638 UNITED STREET

November 27, 2018

HARC Commission Meeting

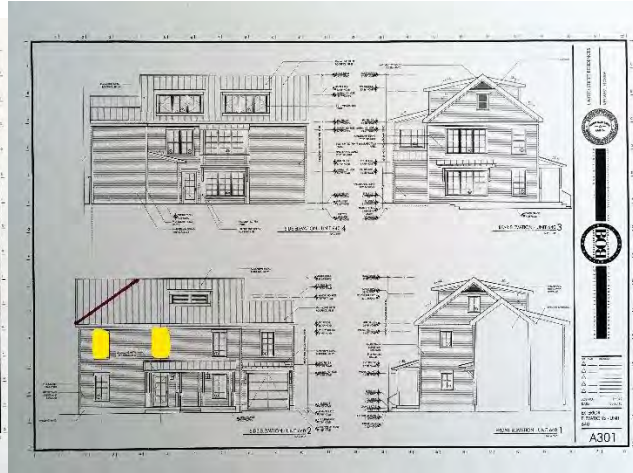
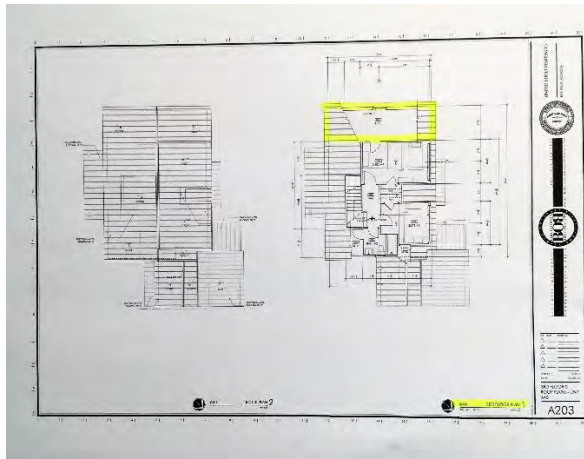
Guideline 14: There must be a consistency of scale and proportion. The width and height of new construction shall be similar to those buildings of the same land use immediately adjacent to it

- Similarly, the density and mass of this project is not consistent with the height of the homes in the surrounding area.

1. Reduce the overall number and size of the homes.
2. Rearrange the plan locating the tallest structures to the Villa Mil (East) side of the lot. This would be more consistent with the height and scale of the neighborhood and would preserve views while minimizing the privacy concerns of the closest neighbors.
3. Reduce the scale of the homes, particularly the height (eliminate the third floors). One and two-story homes are more compatible with the existing neighborhood homes.
4. Eliminate unused attic space on the third floors and taper the rooflines accordingly.
